*Architectural Advisory Committee:  
Request for Design Review and Recommendations*

**Subject:** 433 Main Street Mixed Use Residential / Commercial PDP-20-051

Proposed Mixed-Use Project  
 Anthony Uccelli  
 Main St & Kelly Ave  
 Half Moon Bay, CA

Section Views

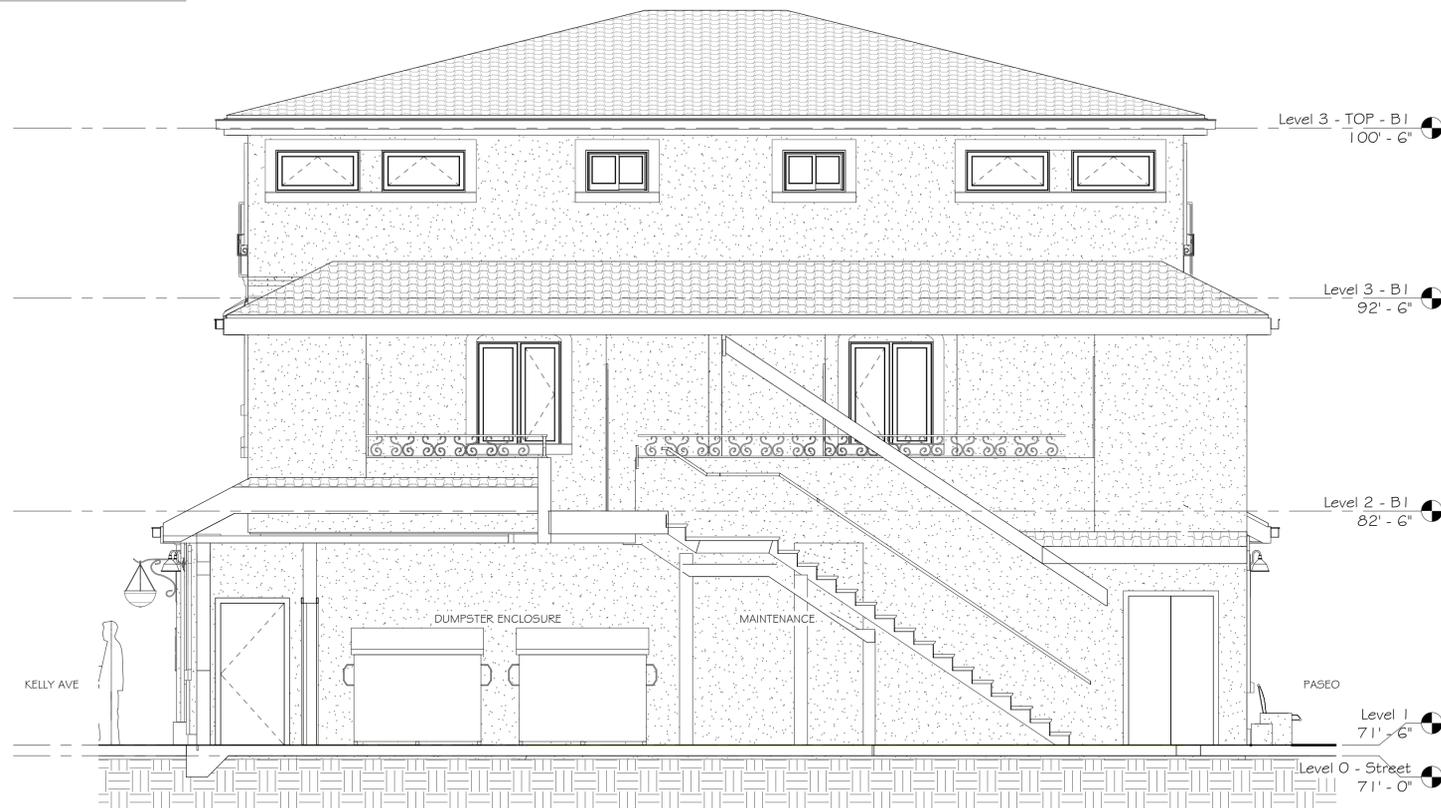
Structural Requirements: Work out the plate heights to ensure there is adequate space for structural elements.

- Further review by the AAC is recommended,
  - **Architectural Design Considerations:**
    - Have the structural details been worked out? You may need more room for heavy beams. Consider extending the height of Building #2 to the maximum allowed height of 36 feet. You will probably need this extra room to accommodate large beams. Consider lowering the ceiling height of the second floor and increasing the height of the third floor. A 9,8,9 plate height would work.

*Response:* Floor-to-floor heights on Building #2 were adjusted to address this comment.
